From: Habib, Donald
Sent: Wednesday, June 20, 2012 8:48 AM
To: maryo@nirs.org
Subject: FW: Draft LNP RAI response - Seismic Evaluation
Attachments: RAI L-0998 Response Outline 06-18-12.pdf

NRC RAI

Response L-0998 Outline:

Figure RAI L-0998-1: Comparison of hard rock UHRS based on the EPRI-SOG/UCSS model from FSAR with hard rock UHRS using CEUS SSC model.

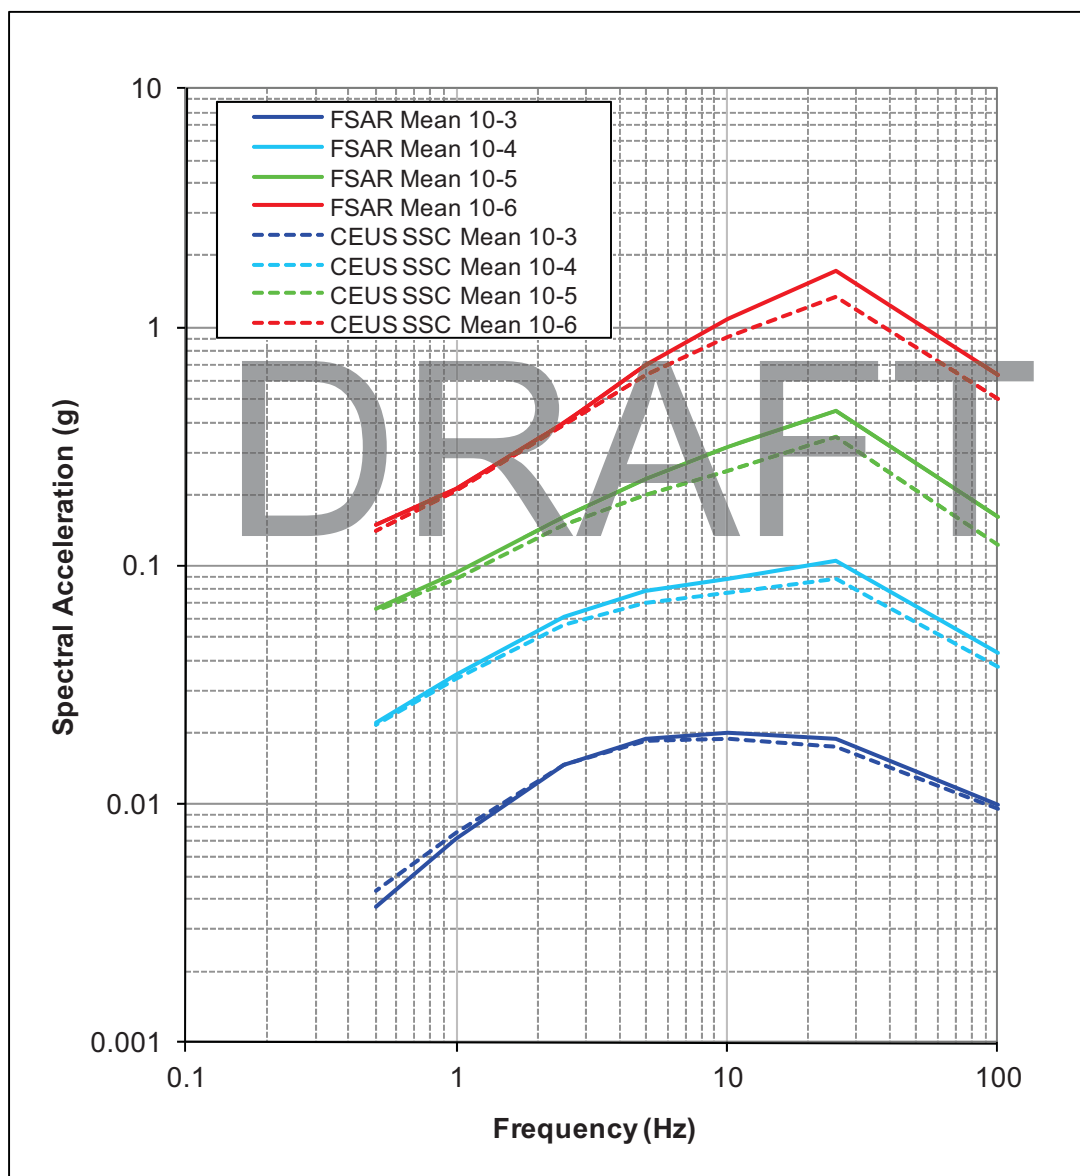
Evaluate the seismic hazard at your site against current NRC requirements and guidance and, if necessary, update the design basis and structures systems and components important to safety to protect against updated hazards (seismic portion only – of detailed Recommendation 2.1 – Enclosure 7 of SECY-12-0025).

Figure RAI L-0998-1 compares the hard rock UHRS based on the EPRI-SOG/UCSS source model used in the FSAR to the hard rock UHRS based on the CEUS SSC source model. The rock UHRS based on the CEUS SSC model are somewhat lower at spectral frequencies above 2.5 Hz and are similar to the Calculation LNP-0000-X7C-031 results for lower spectral frequencies. The only place where the CEUS SSC model produces higher motions is for the 10^{-3} UHRS at low frequencies. This higher hazard is likely due to the larger maximum magnitudes for the distributed seismicity sources in the CEUS SSC model.
